Title - Sujet CCTV AT ATLANTIC INSTITUTIONS	
Solicitation No. - N° de l'invitation 21120-169589/A	Amendment No. - N° modif. 004
Client Reference No. - N° de référence du client 21120-16-2209589	Date 2016-06-09
GETS Reference No. - N° de référence de SEAG PW-\$\$HN-461-70697	
File No. - N° de dossier hn461.21120-169589	CCC No./N° CCC - FMS No./N° VME
Solicitation Closes - L'invitation prend fin at - à 02:00 PM on - le 2016-06-28	Time Zone Fuseau horaire Eastern Daylight Saving Time EDT
F.O.B. - F.A.B. Plant-Usine: <input type="checkbox"/> Destination: <input type="checkbox"/> Other-Autre: <input type="checkbox"/>	
Address Enquiries to: - Adresser toutes questions à: Hallman, Patti	Buyer Id - Id de l'acheteur hn461
Telephone No. - N° de téléphone (819) 420-0339 ()	FAX No. - N° de FAX () -
Destination - of Goods, Services, and Construction: Destination - des biens, services et construction:

Amendment 004 is issued to add additional questions to Attachment 001 – Questions and Answers

ATTACHMENT 2

SHEET NO. 1		PROJECT TITLE	
WESTMORLAND INSTITUTIONAL BUILDING		NCCTV NETWORK BACKBON	
DWG SIZE		DRAWING NUMBER	
B		114101012187WII-NIC-0	
PROJECT NUMBER	CLIENT	PRODUCT	REV
114101012187WII		NIC	0
SCALE	NTS	SHEET	2 OF 2

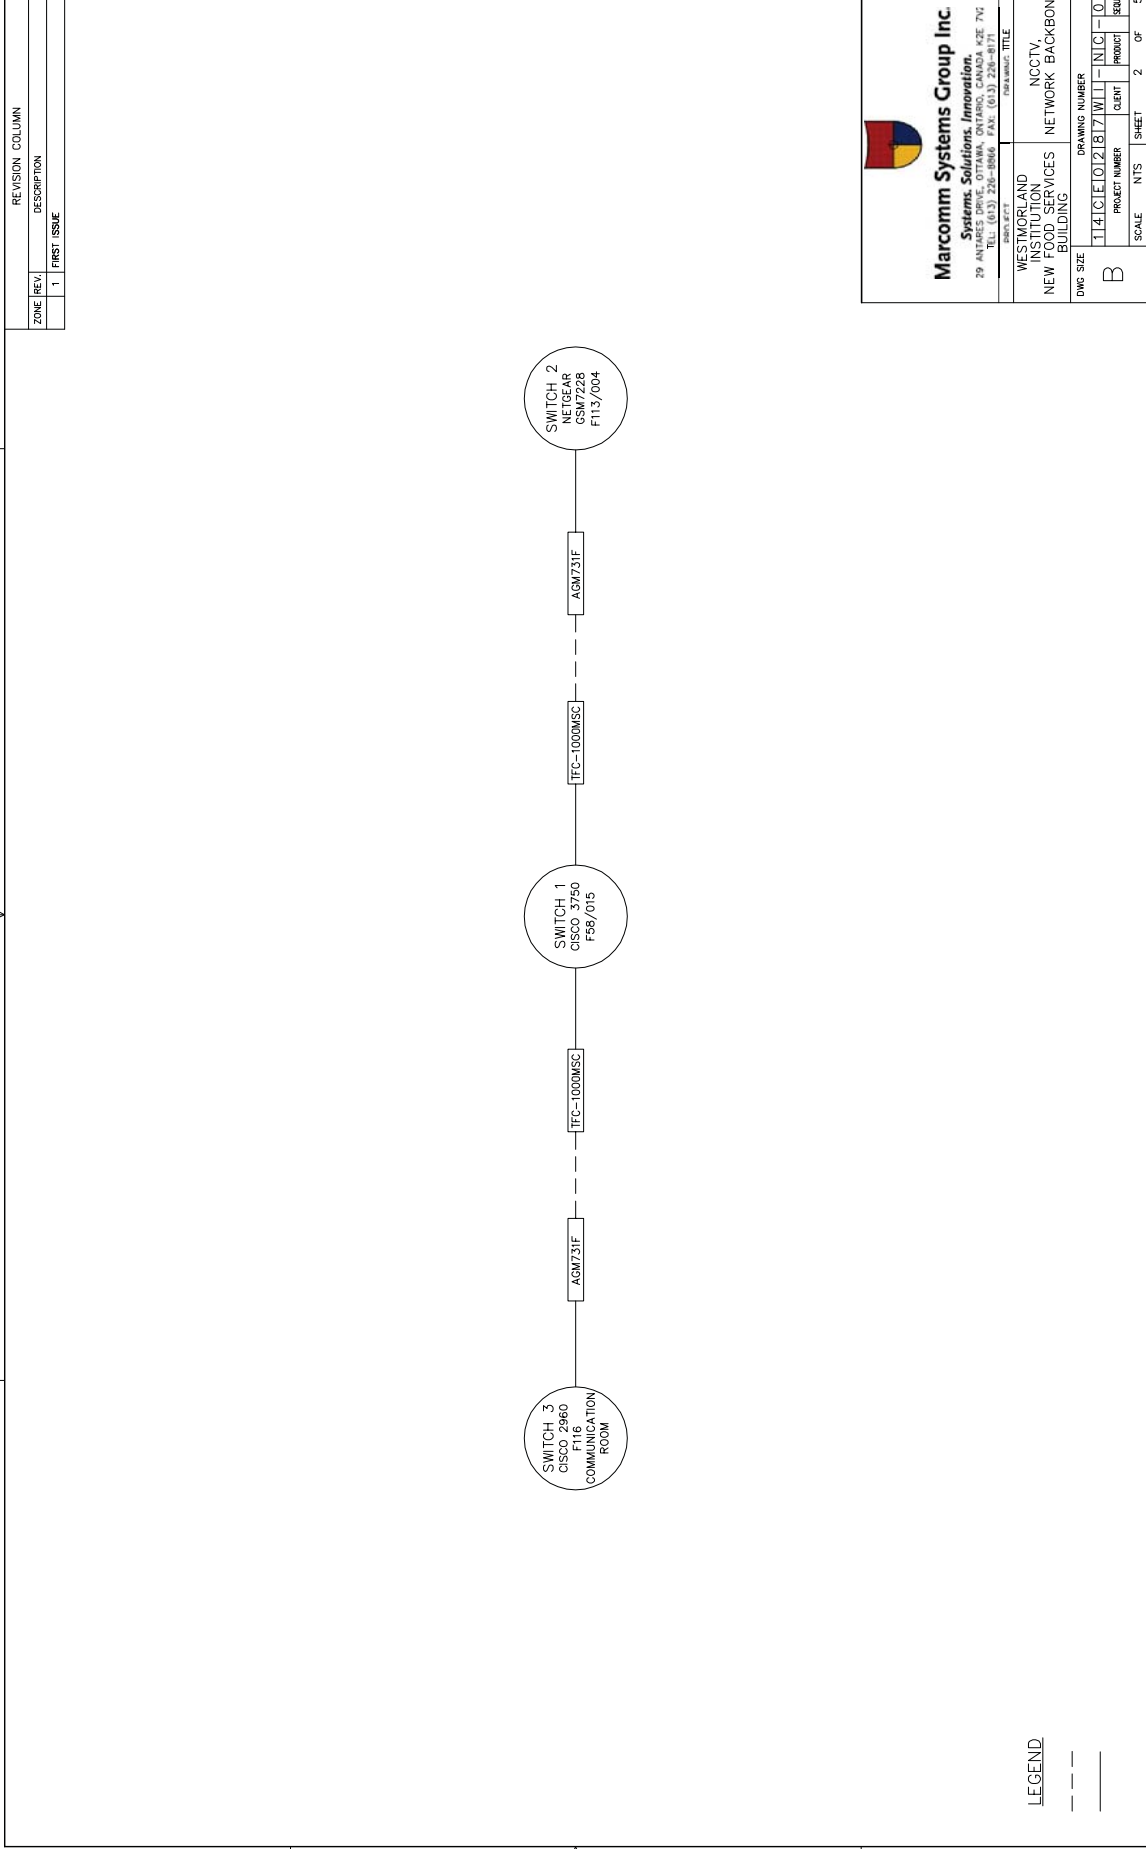
Q88) Dorchester Institution: Is it possible to have information on how the new topology of the security network for Westmorland?

A88) Dorchester Institution: The new Westmorland CCTV topology will be part of the bid design; information on the current Westmorland topology is as per attached files, Westmorland CCTV Network Diagram and Westmorland CCTV Tables.
